White Flint Sector Plan

worksession #6 april 13, 2009

GARRETT PARK ESTATES - WHITE FLINT PARK CITIZENS' ASSOCIATION

**Presentation to the Montgomery County Planning Board
March 30, 2009**

Where’s the core?

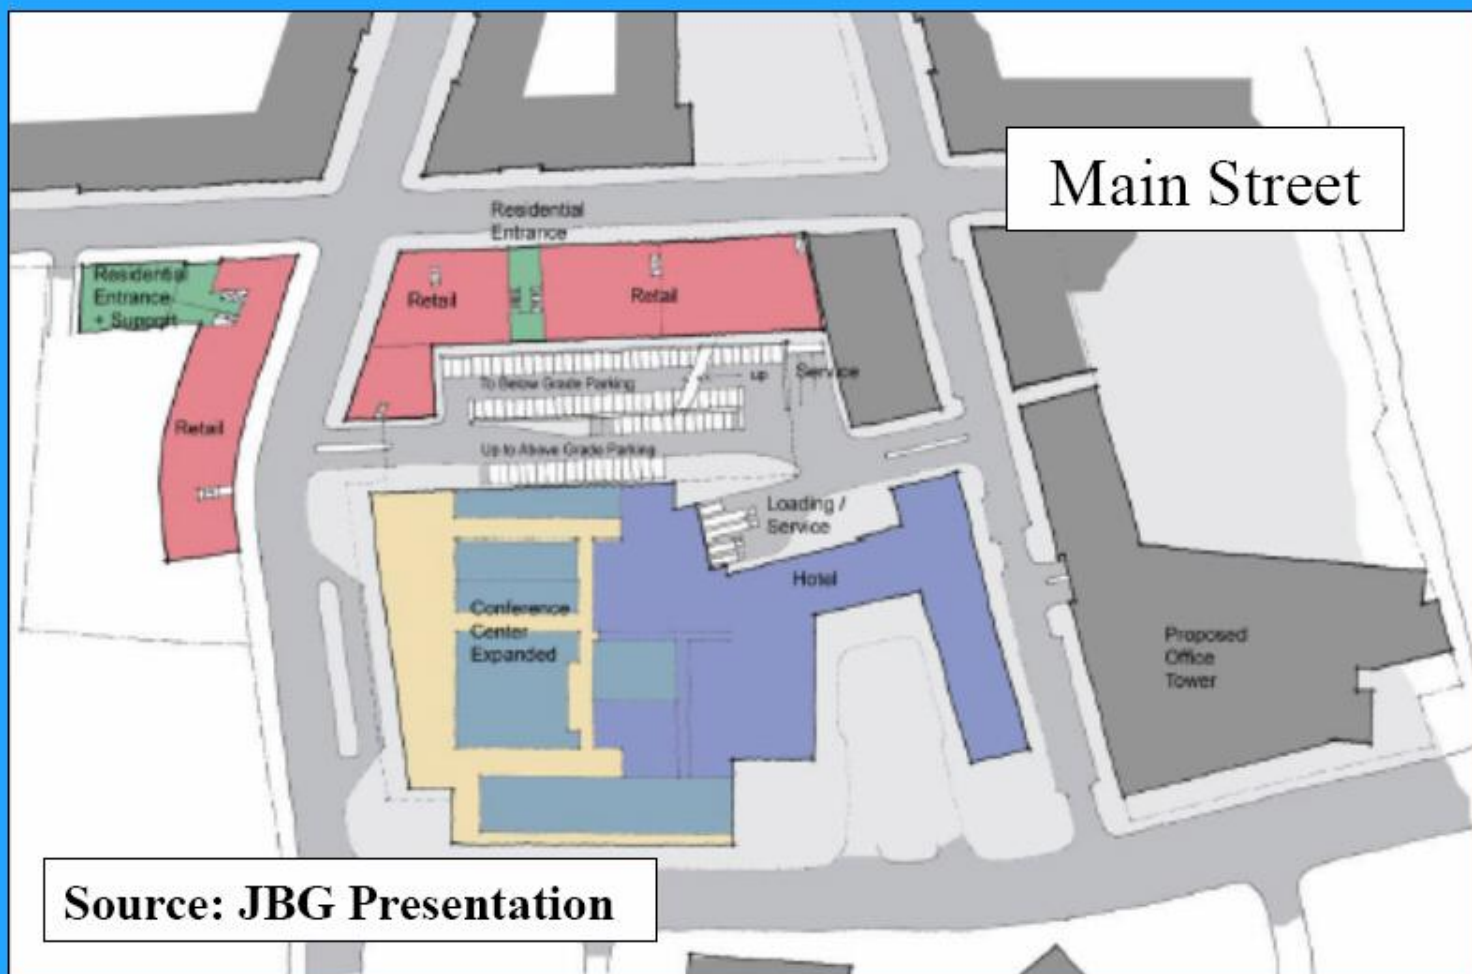
- Three developers presented on Metro West (JBG, Gables, Nissan-VOB)
- None embraced Main Street/Civic Green focus
- JBG Presentation
 - Five of ten slides focus on Rockville Pike Tower
 - No separate slide on Main Street and Civic Green
 - Brief reference: Community Street Retail...Along Main”
- Location at heart of sector places important responsibility on these developers
- Civic Green and Main Street must be “Iconic Landmarks” incorporated into their designs

“Smart” Core: Walkability

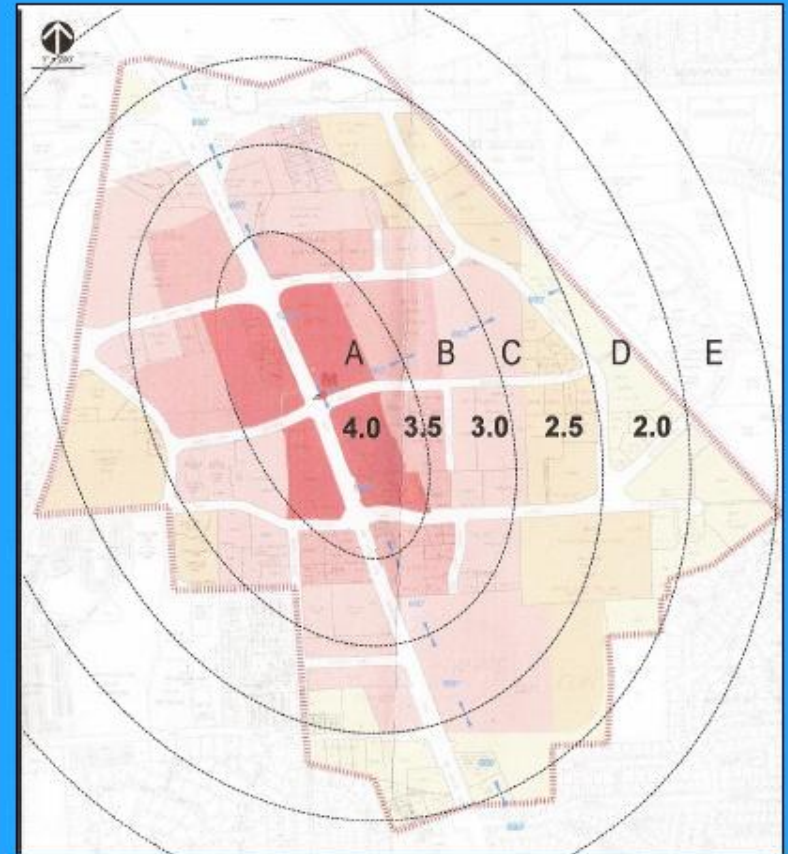
- Oppose Elliptical concept:
- Moves centerpoint south to existing Metro exit, away from Main Street east-west axis
- Allocates density by developer, not by distance or walkability
- Extends urban sprawl south along Pike

Strathmore and Kenilworth Aves, Garrett Park

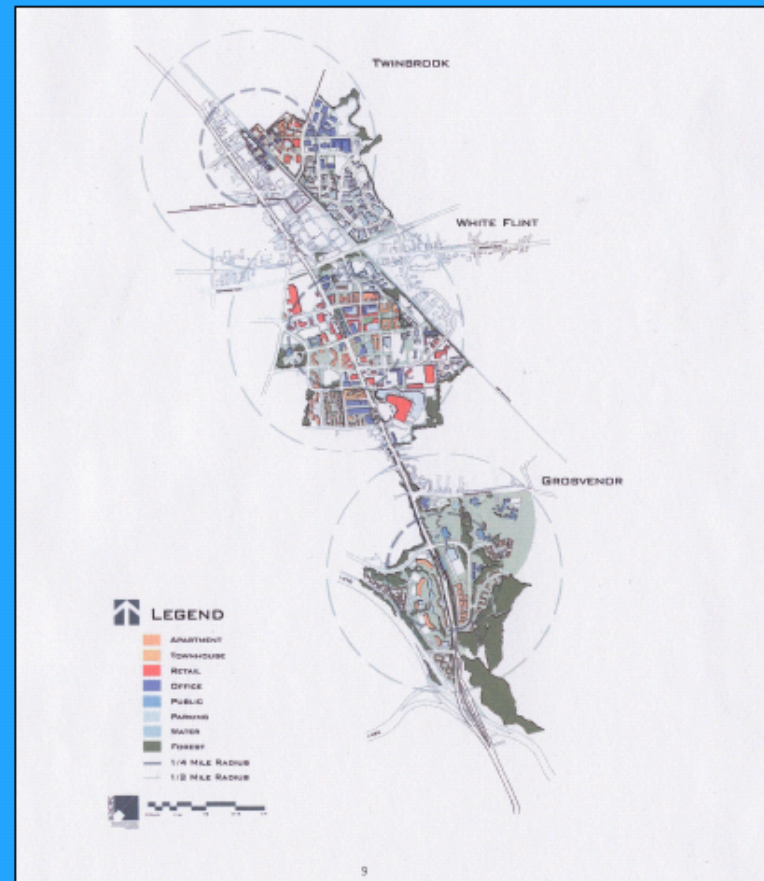
- Transportation Analysis - Strathmore Ave. and Rockville Pike
- Essential entrance and exit for communities
- Strathmore Ave. not in Sector Plan, but impact of increased traffic is vital concern

“Smart” Core: Compatibility

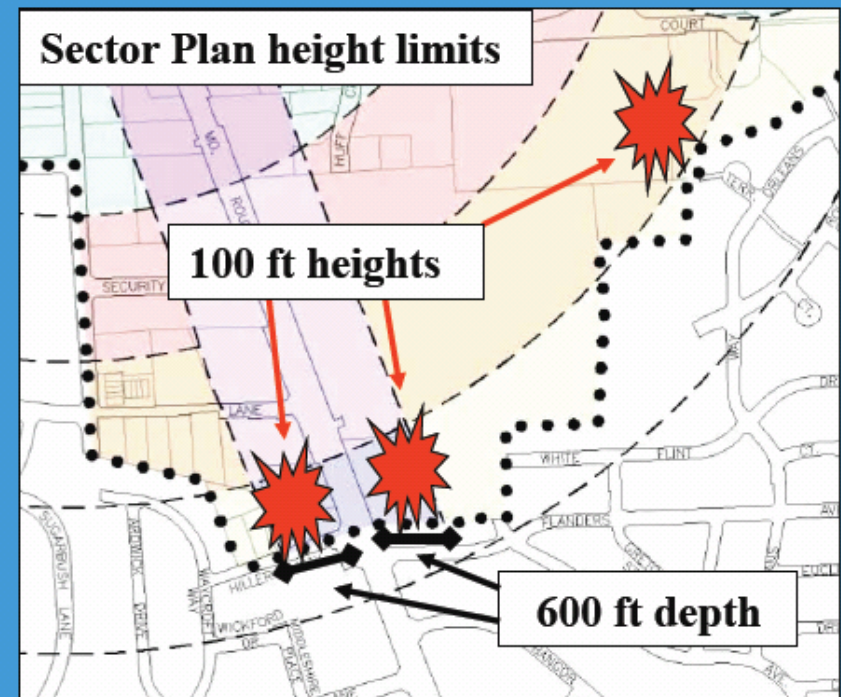
- Compatible building heights
 - Object to allowing 100 ft buildings adjacent to communities on both sides of Pike
 - Object to envelope extending 600 feet in from Pike
 - Existing medical bldg 75 ft high, extends ~67 ft deep
 - 36 ft – 50 ft maximum height at border
